**Engineering Change Notice – Rear Tape Changes**

TCG058WXLBPVNN-AN30

# Engineering Change Notice

## (Part Number:TCG058WXLPBVNN-AN30)

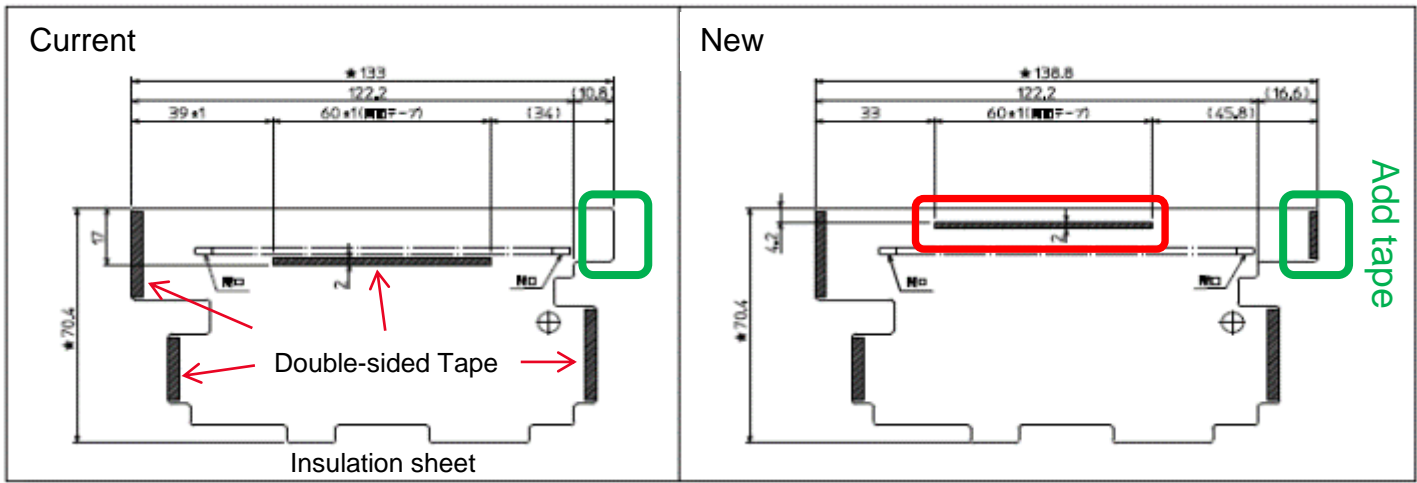
■ Double-sided Tape

For fixing insulation sheet

■ The contents of change

By changing the tape attachment position, stress on the FOB connection area is reduced. Also add tape to help fix the insulation sheet.

## ■ Tape

For holding FPC

## ■ Comparison of changes

Current	New
 <p>12mm</p>	 <p>20mm</p>

Reduce the risk of floating FPC by expanding the tape width.
